Access Compliance Report

Public Rights-of-Way

(Curb Ramps)

Intersection ID: 9658	Main Street: VANDERBILT_RD	Cross Street: WOODWARD_AV	Location: NE
ADA ID: FA7F227DADA2	Ramp Type: Para	Initial Pass/Fail: Fail	Overall Compliance: No
Codes/Mitigation Info/Possible Solution		Field Measurements/Component Compliance

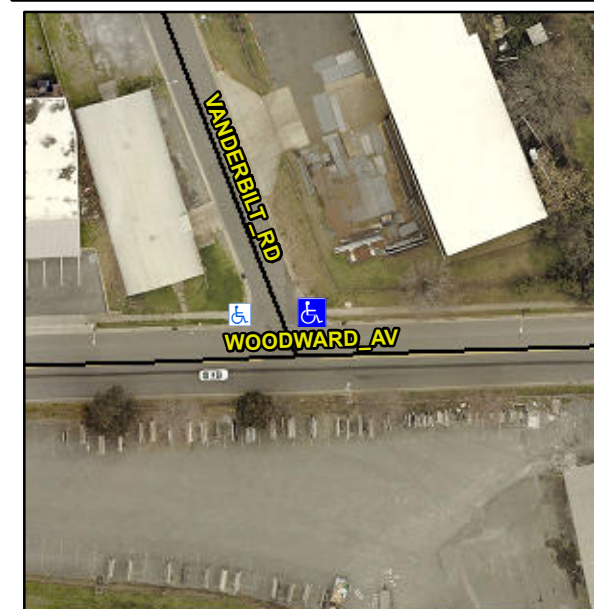
Surveyor Notes:

CURB GAP 1.0

PROW/ADA:

R304.5.3, R304.3.2

Possible Solutions:

Remove & Replace Entire Ramp.
